## AMENDMENT OF SOLICITATION/MODIFICATION OF CONTRACT

2. AMENDMENT/MODIFICATION NO. 2	3. EFFECTIVE DATE See Block 16C	4. REQUISITION/PURCHASE REQ. NO. 4200541292	5. PROJECT NO. (If applicable) 99018
6. ISSUED BY CODE	OP-ES	7. ADMINISTERED BY (If other than Item 6) Same as block 6	CODE
John F. Kennedy Space Center, NASA Procurement Office, OP-ES Kennedy Space Center, FL 32899

The purpose of Amendment 2 is to:

4. **REFERENCE:** Drawing 79K39914 Sheet M100

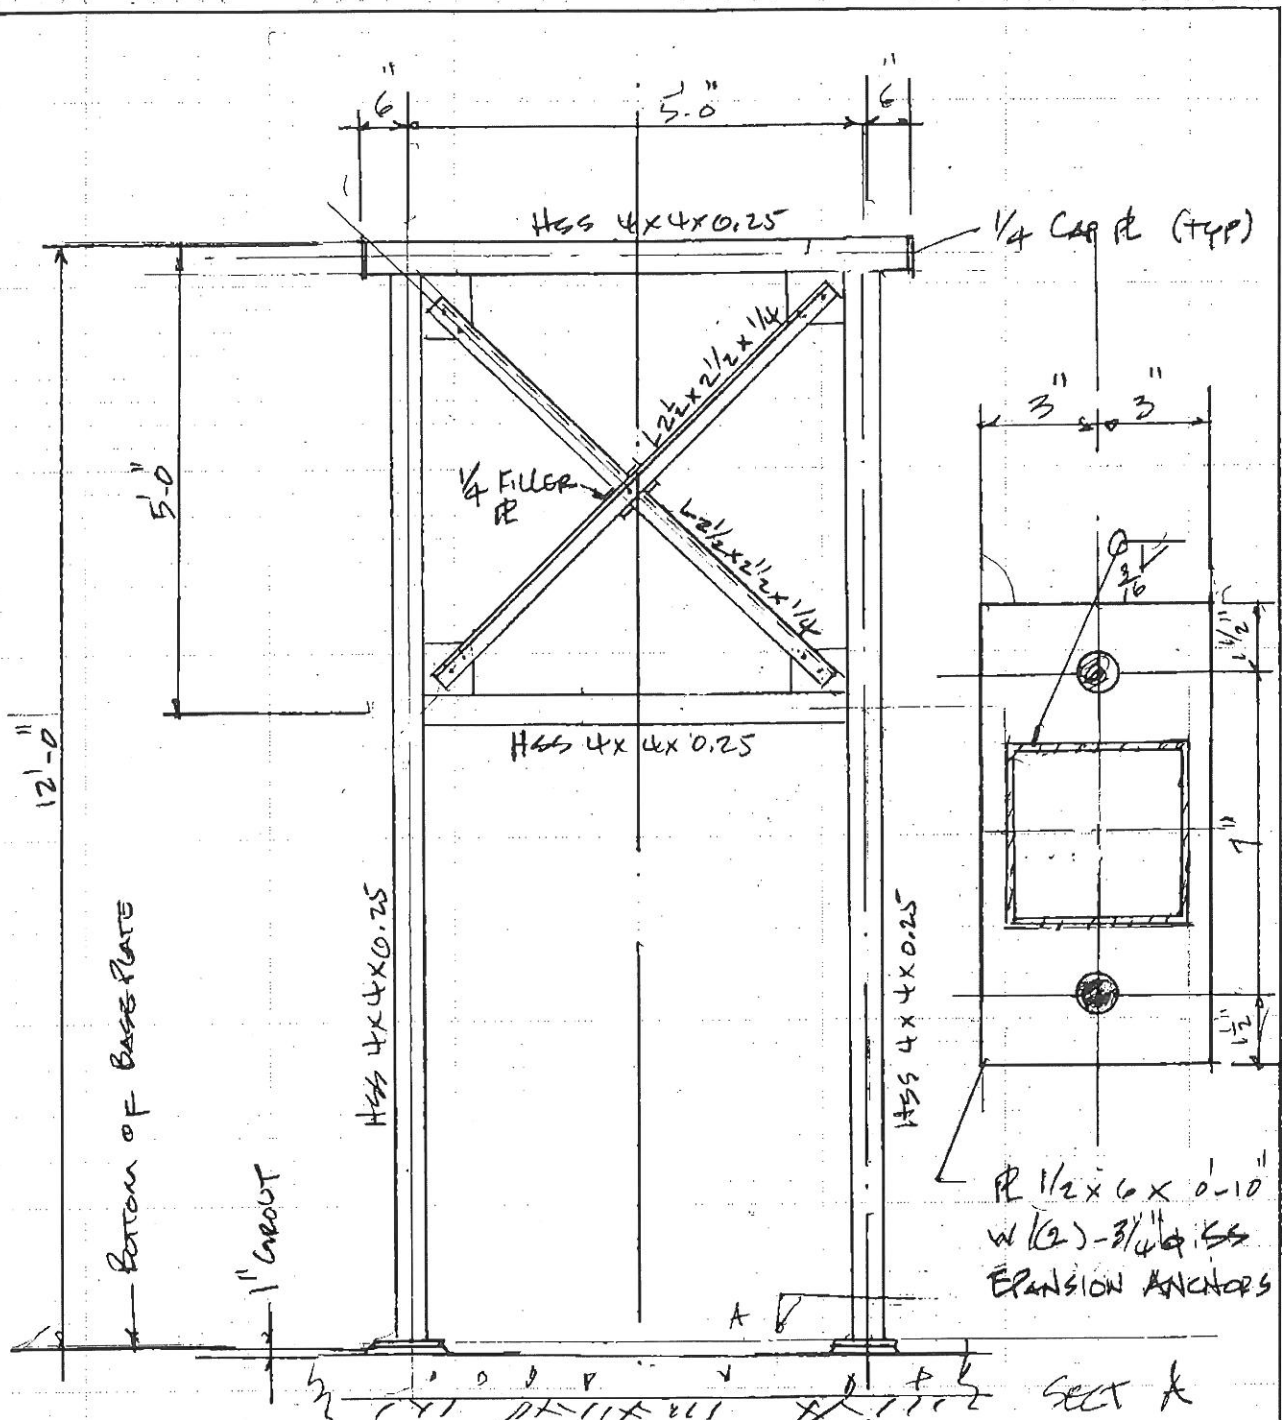
**QUESTION:** At the exterior of the building and on the exterior air conditioning duct is a note "DUCT SUPPORT WITH SADDLES". Please provide a sketch/detail and quantity of supports for the exterior duct.

**RESPONSE:** See Attached Sketch.

PLACE SUPPORT ON NEW 6" CONC. SLAB  
SUPPORT TO BE NOT DIPPED GALV. AFTER FABRICATION  
CRUST TO BE NON-STEEL & NON-METALIC
